LAKESIDE ENGINEERING

Re: Bowers Business Park
Site C734145
Soil Pile 2 characterization – Remedial Investigation Work Plan Addendum
Lakeside Project No.: 20210323.12

Attachment 1 – Figure 1 – Lot 2 Existing Soil Pile

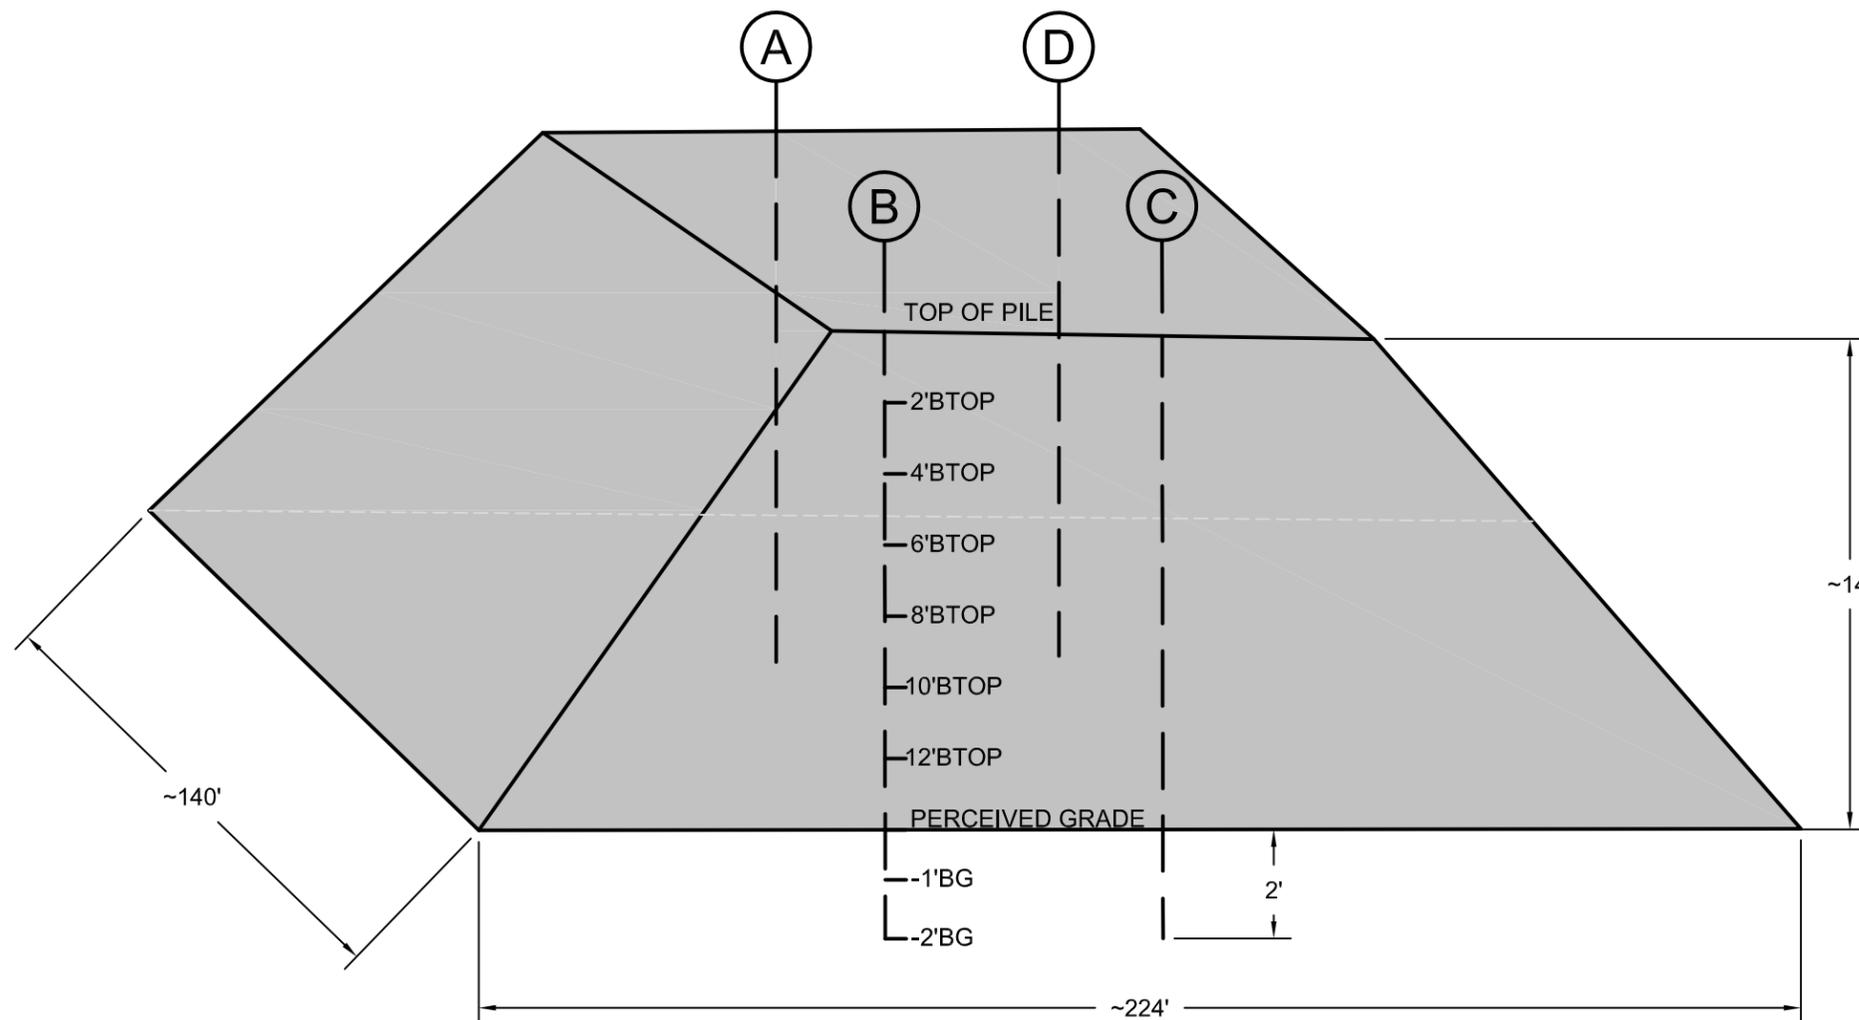
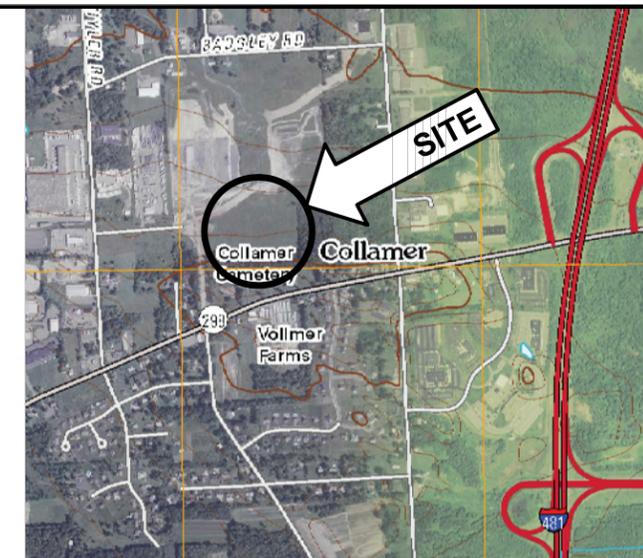
- The pile is approximately fourteen feet high. An additional four (4) soil borings will be completed atop the pile and will be field located near the corners of the “flat” area. These four borings will be advanced to a depth of approximately two feet below the bottom of the soil pile into native soils beneath. Soil samples will be collected for laboratory analysis (for PBCs Only) at intervals every 2’ below top of pile (BTOP) until the existing grade of the surrounding area is reached. Once the original grade is encountered, PCB soil samples will be collected at 0-2” below the native vegetative layer (BNVL), at 1’ BNVL, and at 2’ BNVL (see figure 1, attached). The location of original grade will be determined using survey equipment to establish the height of the pile at each sample location and thereby determine the depth to original grade.

- Sample intervals 4’, 8’, and 12’ BTOP will be analyzed initially, while the 2’, 6’, and 10’ BTOP intervals will be held pending the receipt of the 4’, 8’, and 12’ BTOP results. Additional samples will be analyzed only if results of the first group indicate PCB concentrations more than 25 ppm. These results will be used to subdivide the pile into sections for disposal.

- Additional samples below the pile will be collected for laboratory analysis as required in the RIWP for general site characterization. Again, once the bottom of the pile is reached, the 0-2” and 1’ BNVL in-situ samples will be analyzed for total PCBs only. The 2’ BNVL sample will be held and analyzed only if the 1’ BNVL sample indicates total PCB concentrations greater than or equal to 1 ppm. Further, based on the results of analysis to date, we are not proposing to analyze for VOCs, SVOCs, pesticides/herbicides, or metals. To date none of these contaminant classes have been encountered at the site except for one detection for DDE have been observed at concentrations that exceed the commercial, or in most cases, unrestricted SCOs.
